ERROR DOCUMENTATION

THE CONVENTION (1968),
THE EA (1971), RE2 (2010)

Presentation to
Group of Experts on Road Signs and Signals, WP.1, UNECE
M. Pronin, Consultant
25-26 September 2014, Geneva

Page 35, Sign A, 27, Tram Crossing – “To give warning of an intersection with a tramway line, **unless** such intersection is a **level-crossing** as defined in **Article 1 of the Convention**, symbol A, 27 may be used.”

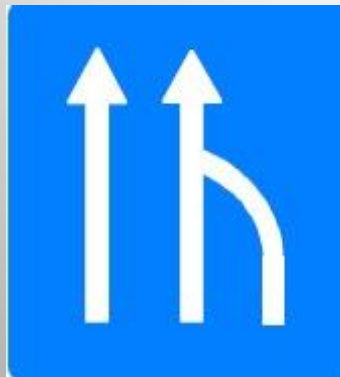
Article 1, (g) – “ ‘Level-crossing’ means any level intersection between a road and a railway or tramway track with its own track formation; ”

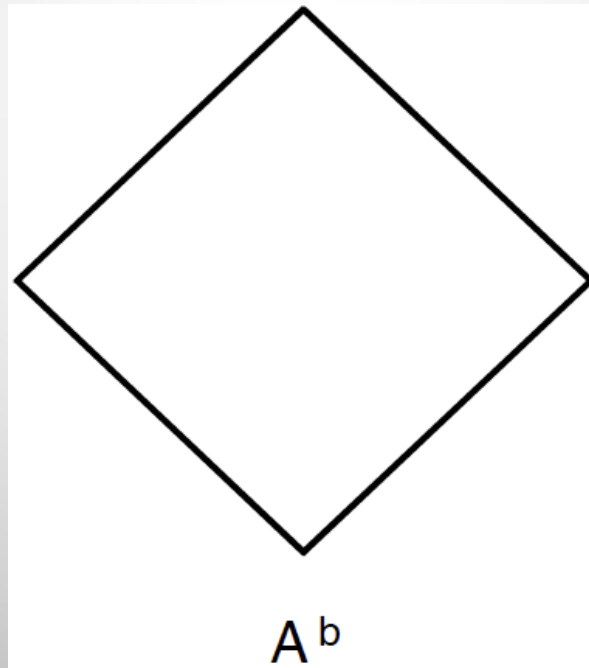
The design of most signs is described in words and illustrated with an image. However, some designs are described only in words; others have an image with no words. Hazard marker colors, for instance, are not illustrated, which has resulted in a variety of colors and patterns not included in the VC or EA.

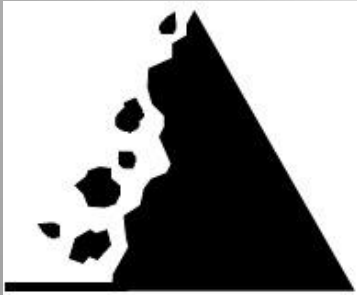
The symbols for A, 11a/b are supposed to fit into the sign corner.

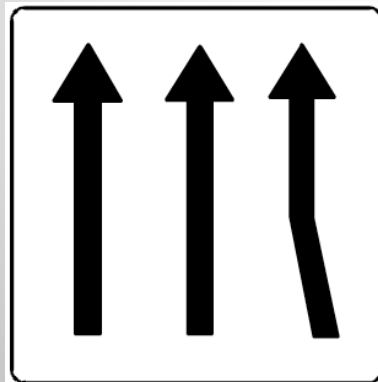
The symbols for C, 3e and C, 10 should be white, not gray, since gray is used for end of prohibition.

G, 11^a

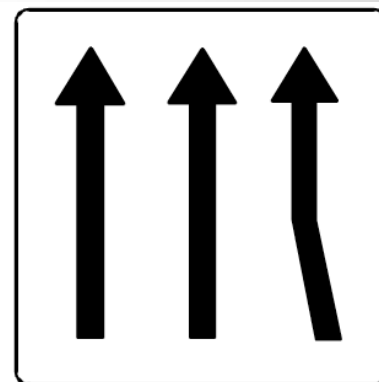
Two numbers were assigned to the same sign.

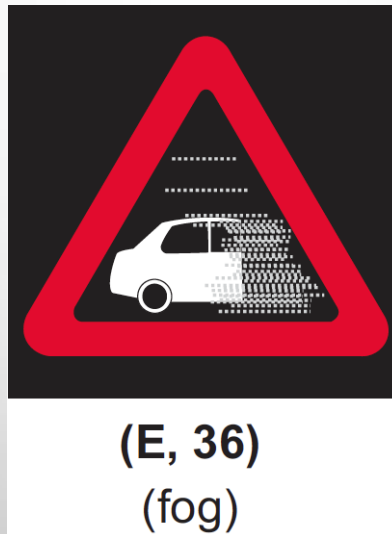
The warning sign for fog is labeled E, 36 instead of A, 36.
